Mealstream EC501 (Series 5) CTM3 240V, 60Hz
FCC ID: PCVCTM3246015A
FCC Class II Permissible Change

Description of changes

Heater Control Circuit Proposal

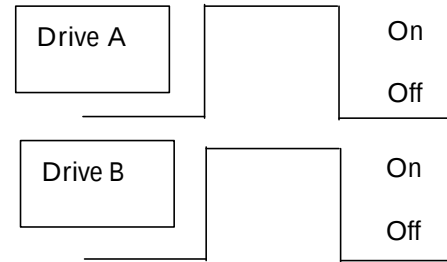
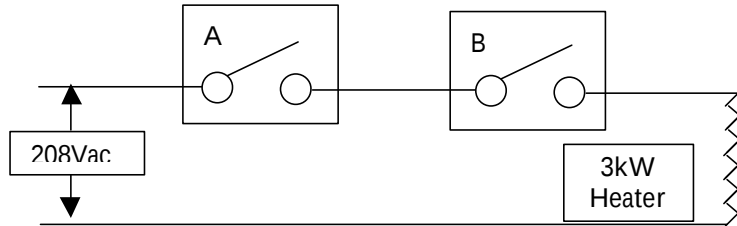
5. Inclusion of Opto-Triac (30Z1189) within the heater control circuitry.

Refer to the block diagram at the end of this document.

A Semiconductor Triac device has been added in the heater control circuitry. Before the modification, the convection heater element was controlled by two series connected relay contacts. The two relay contacts were operated sequentially but could be switched whilst current is flowing.

The modified circuit uses a Triac, which performs the function of zero crossing detection. This allows sequential switching of the relay contacts such that there is minimum current flowing when the relay switch contacts change over.

The control logic to drive the Triac is isolated from the mains switching voltages by means of an opto-isolated triac linked to the switching triac.
